KWM-380 TRANSCEIVER (622-5093-101)
HF-380 TRANSCEIVER (622-3580-101)
RECEIVER-EXCITER CIRCUIT CARD A3 (638-6908-001)

SERVICE BULLETIN NO 1**PRODUCT IMPROVEMENT**

This is a nonmandatory service bulletin which applies to the following:

Power Amplifier A1A1,
Schematic Diagram
Figure 2

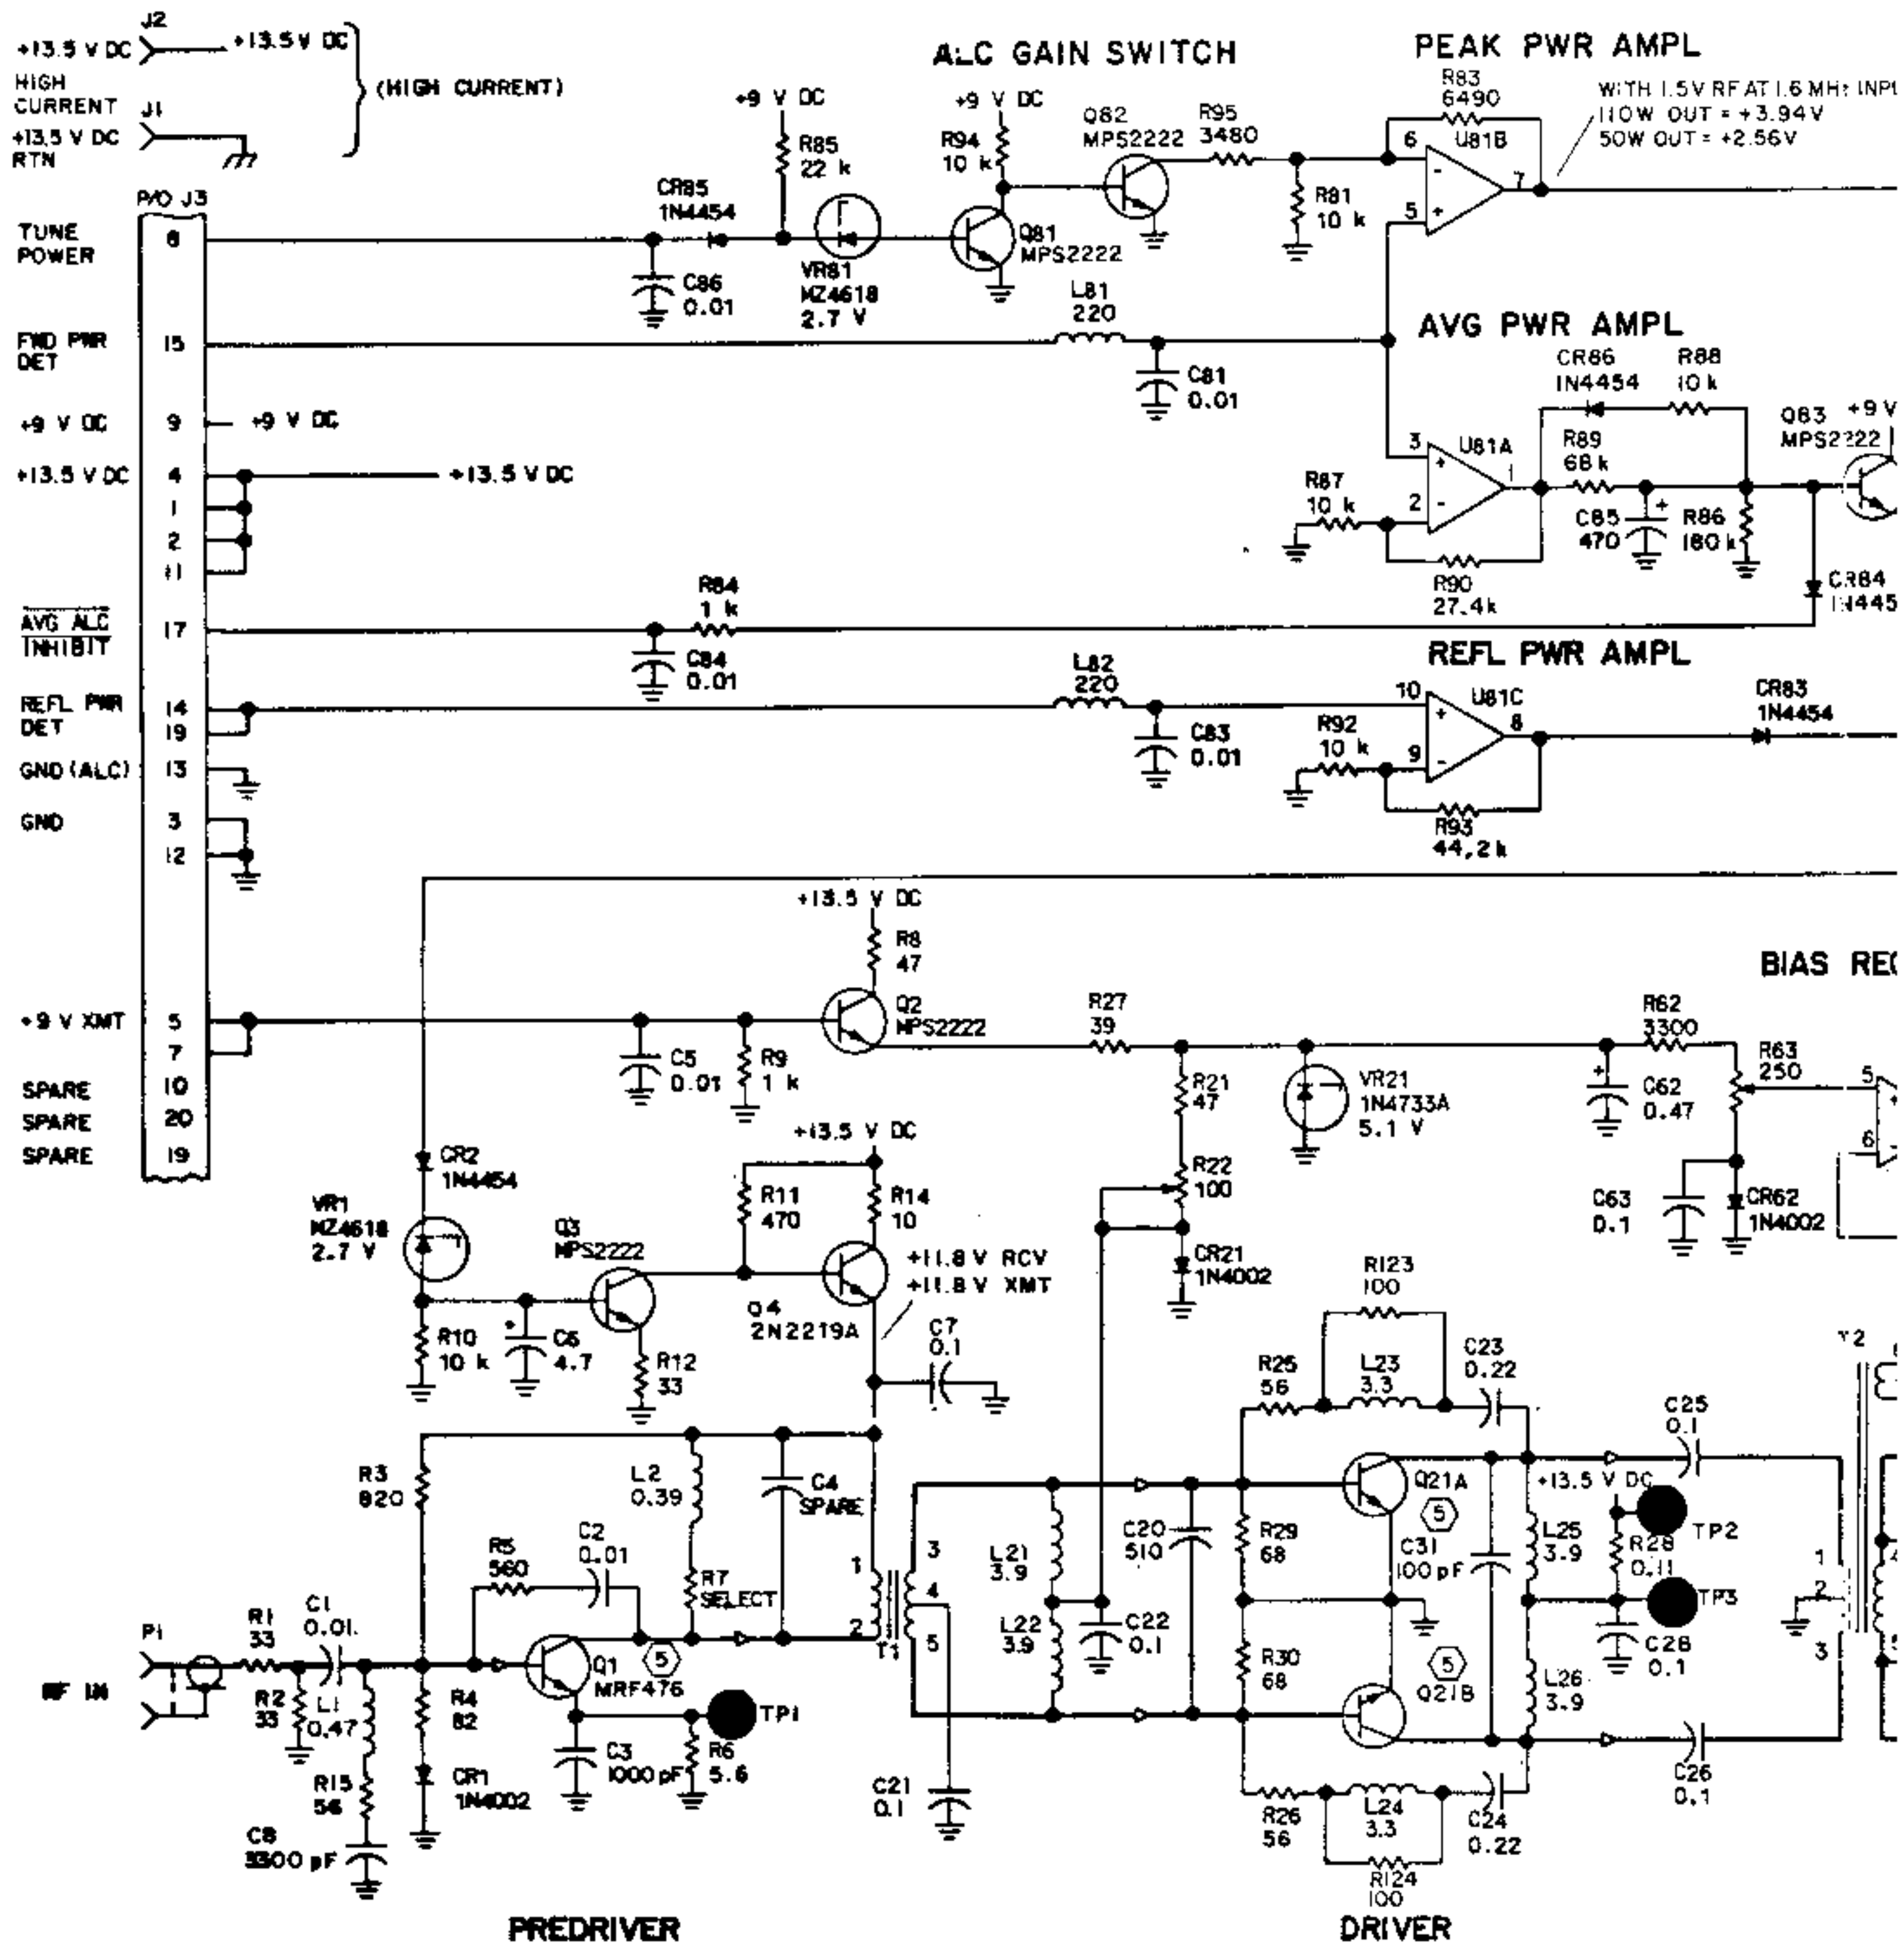
NOTE: LEADS FROM T2 AND T3 MUST BE CAREFULLY POSITIONED AS SHOWN TO PREVENT DESTRUCTIVE OSCILLATION.

Transceiver, Bottom View
Figure 1

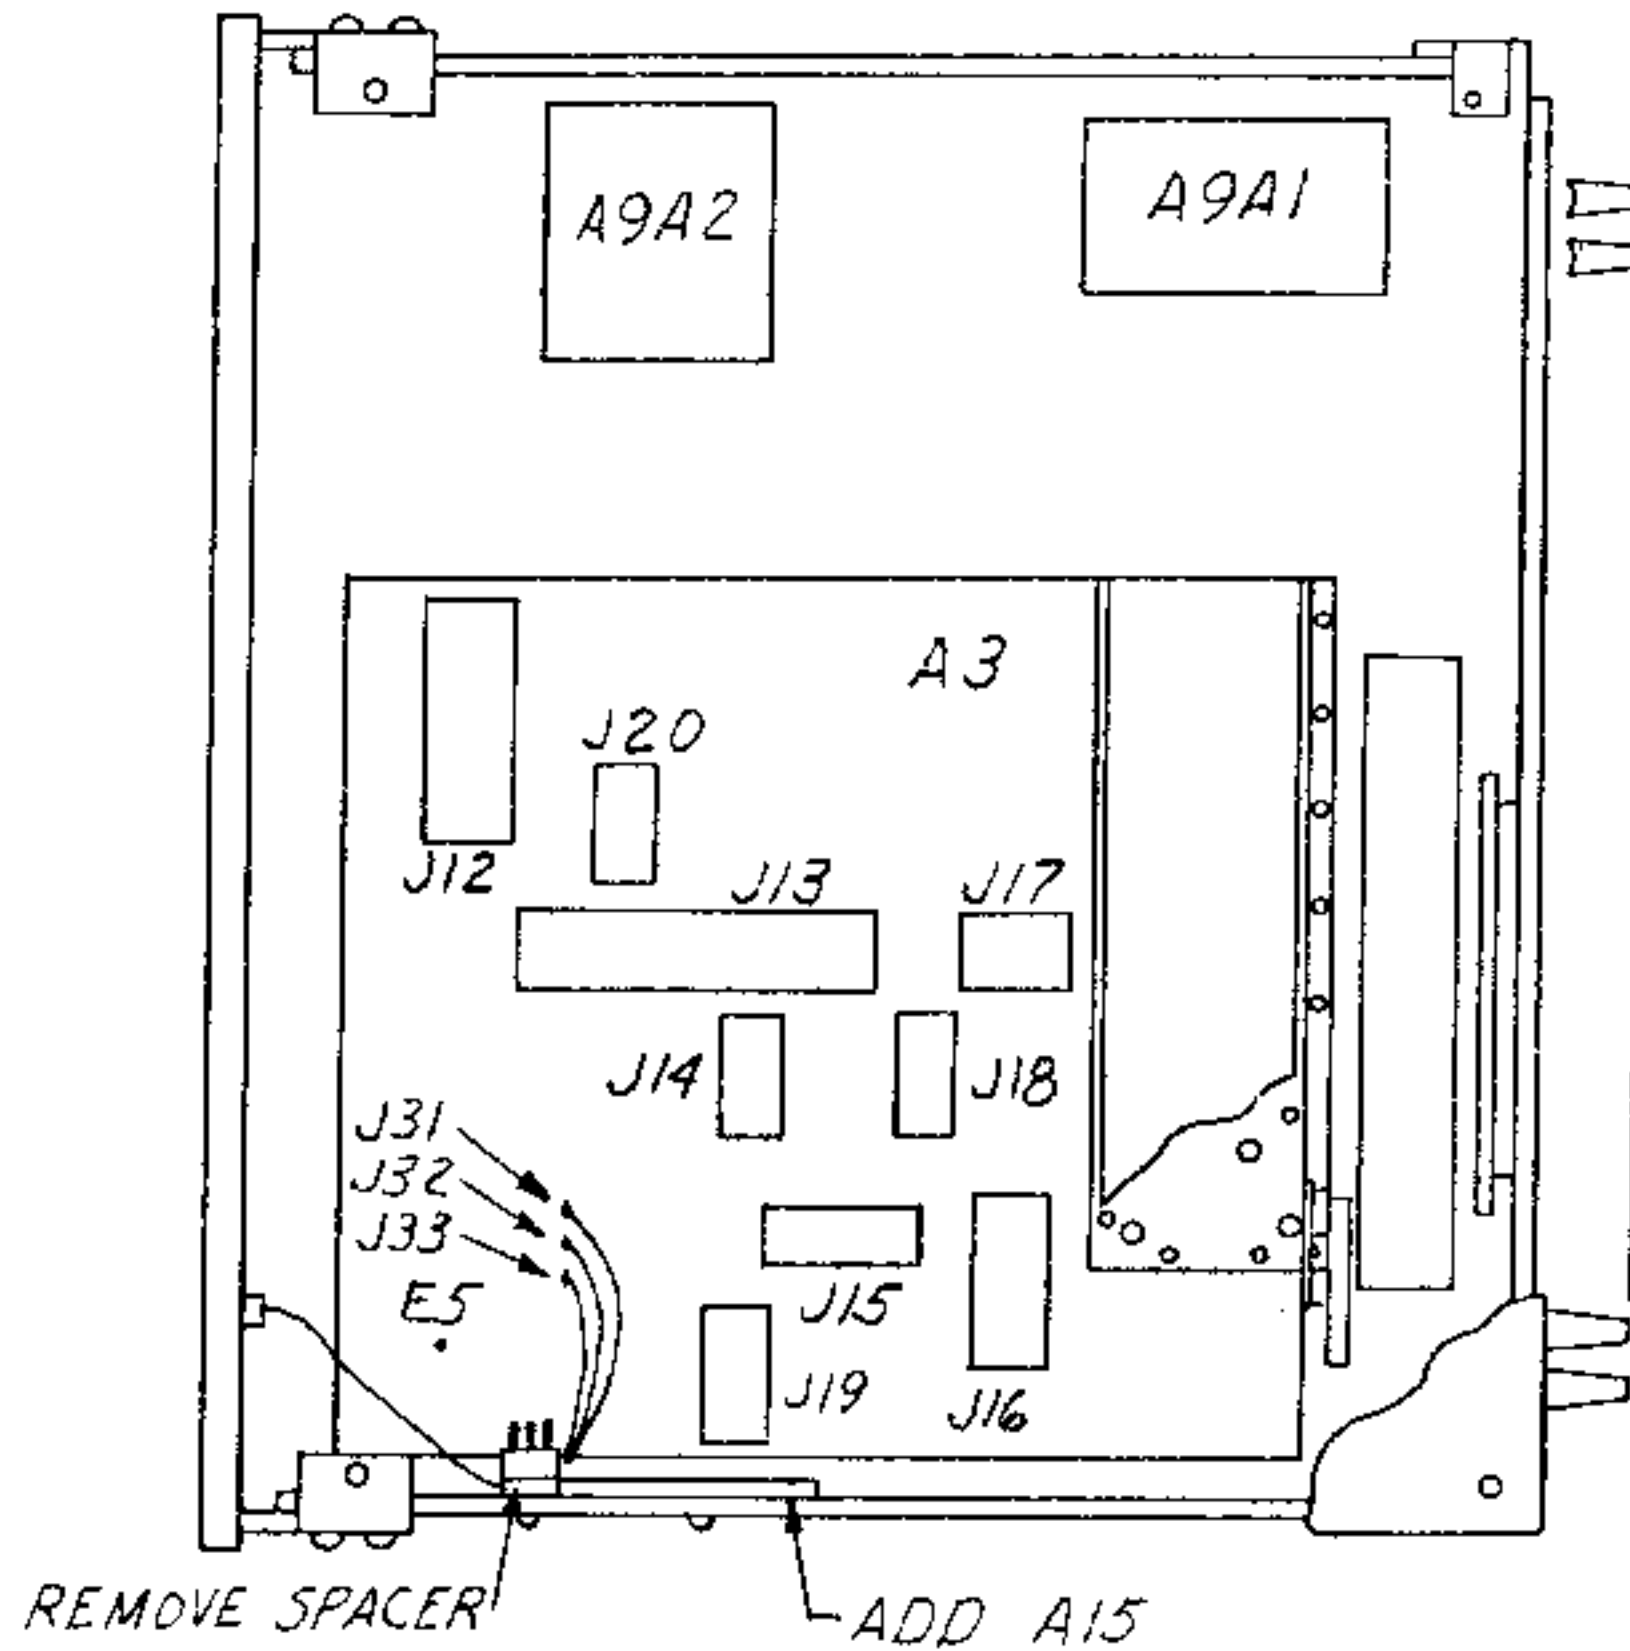
- E. Remove spacer as shown in figure 1.
- F. Install mounting bracket and circuit card A15 (step D) into transceiver using screw where spacer was removed and one additional screw (343-0167-000) in an existing hole in chassis.

Low-Pass Filter Card A15
Figure 2

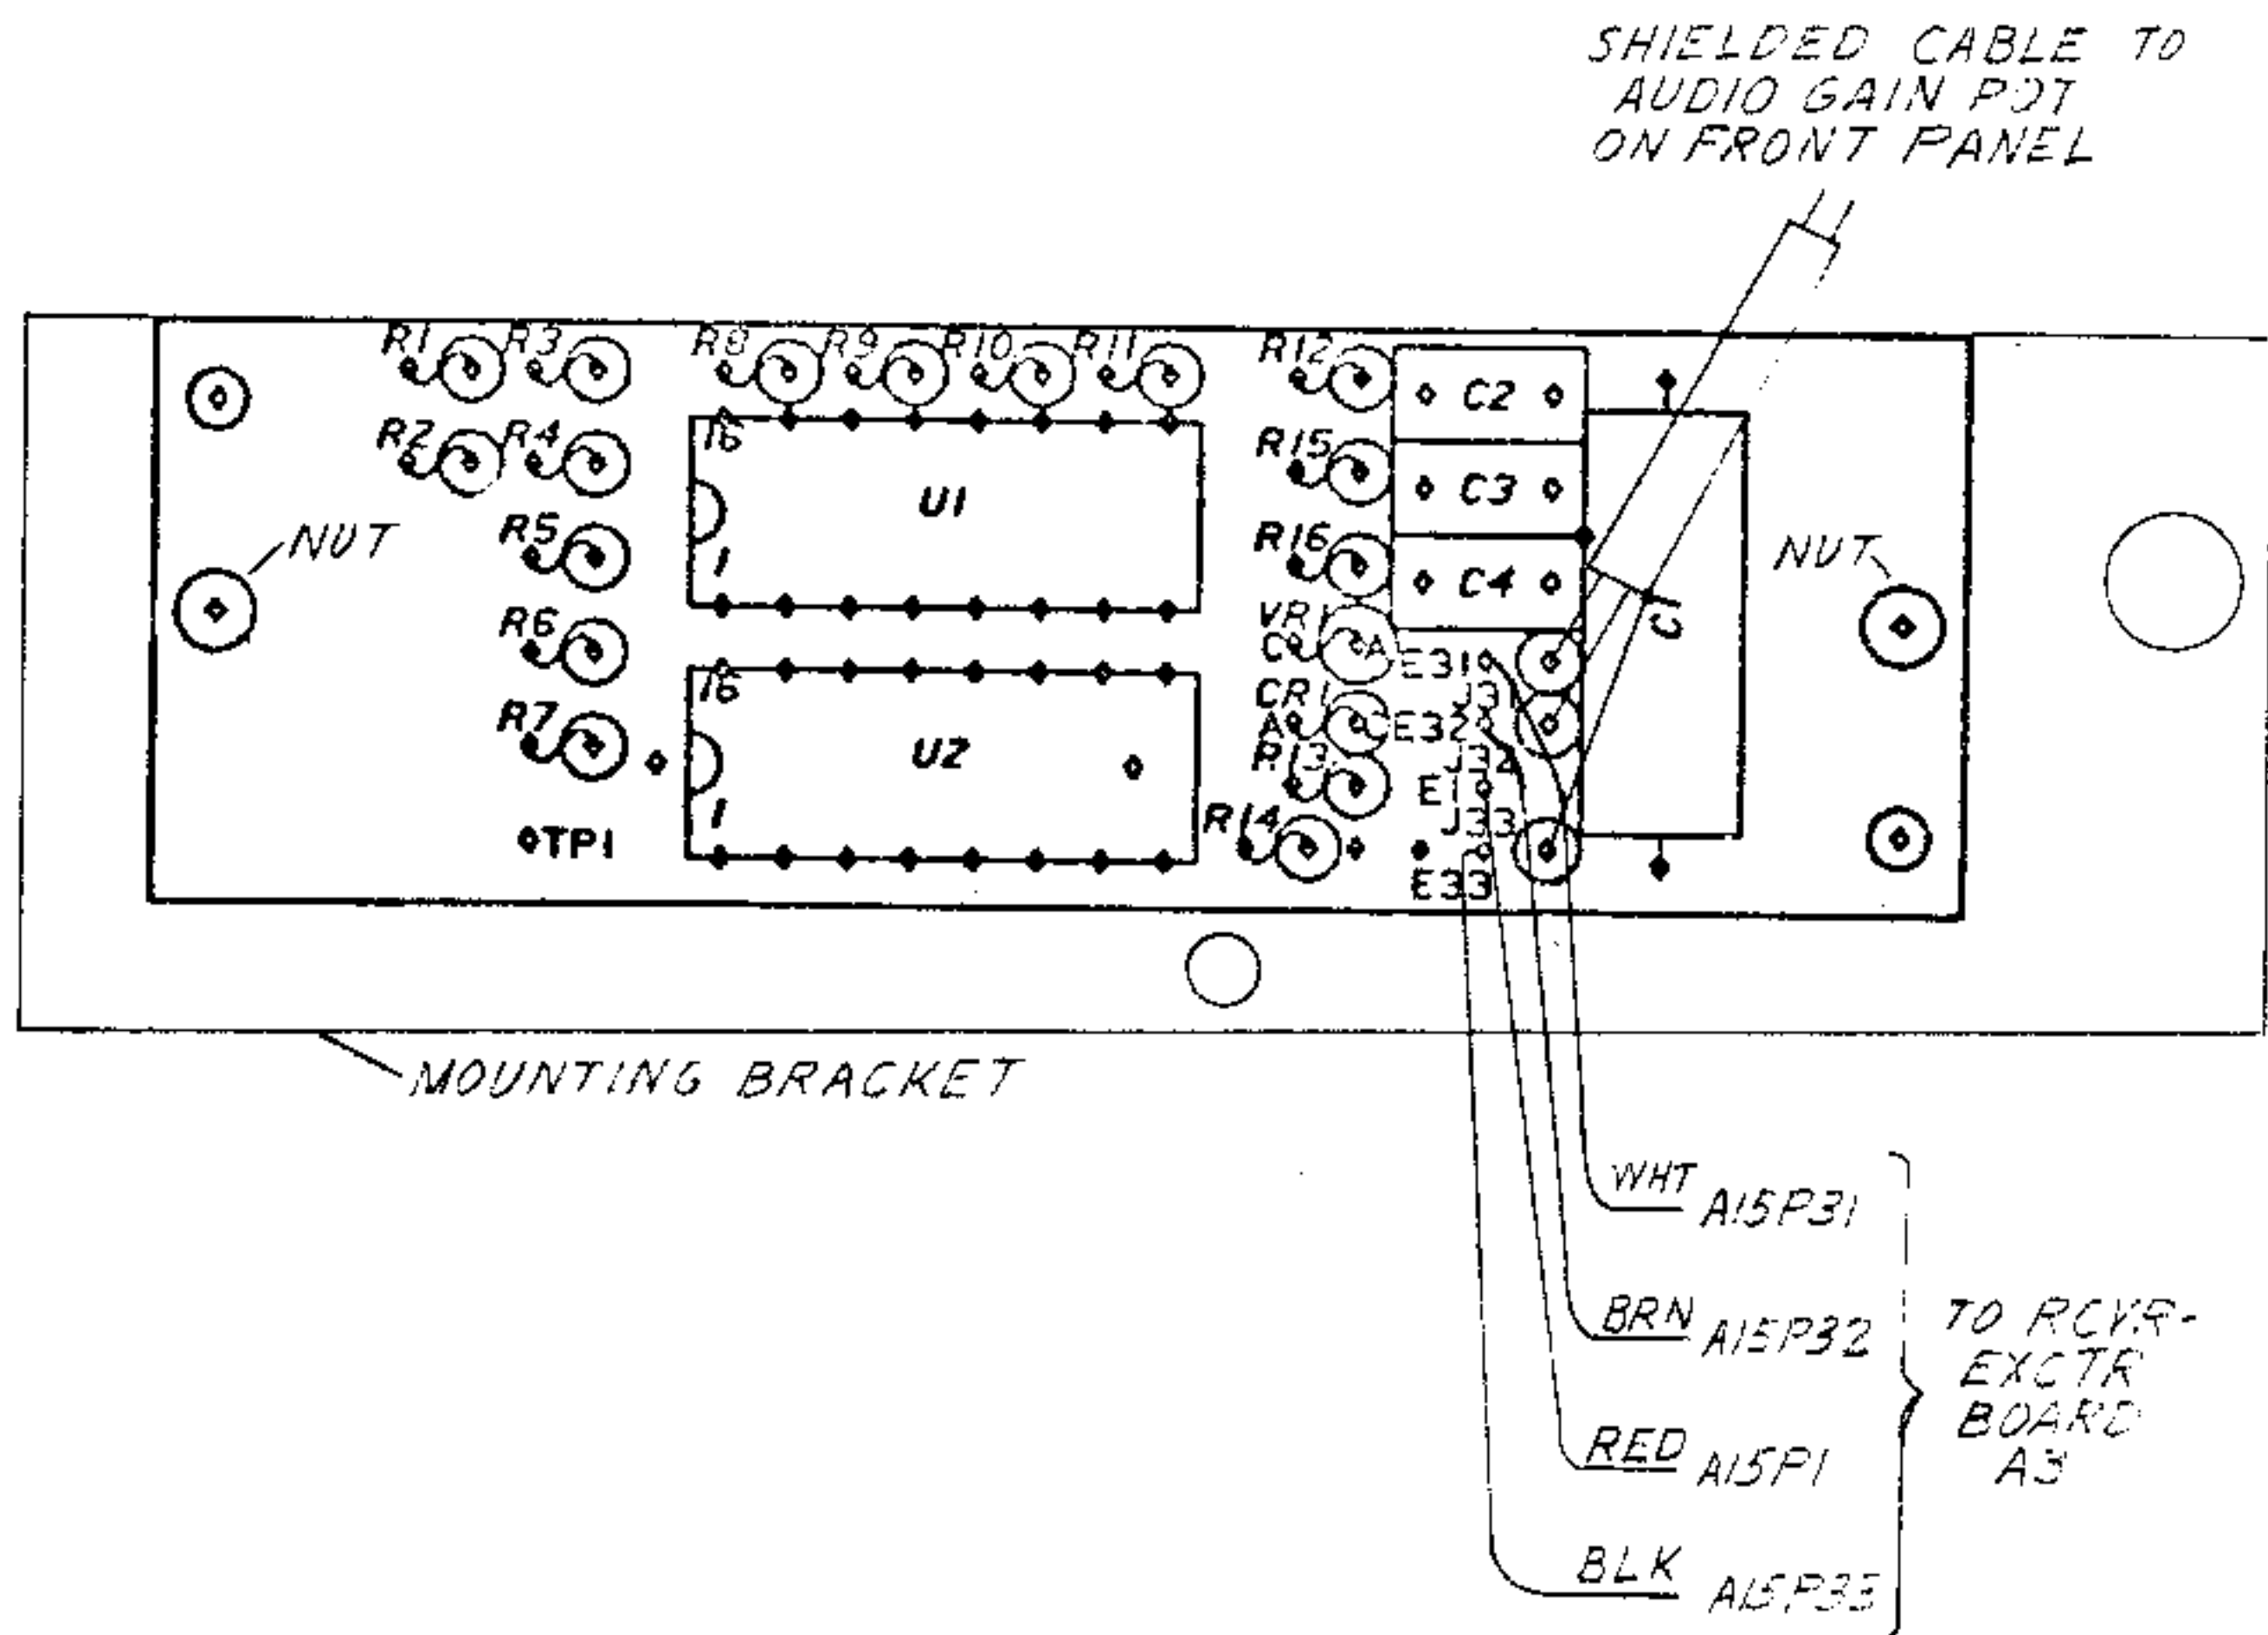
- D. Install filter circuit card A15 (646-5802-001) onto mounting bracket (647-2929-001) using two hex nuts (333-1299-000). Refer to figure 2.
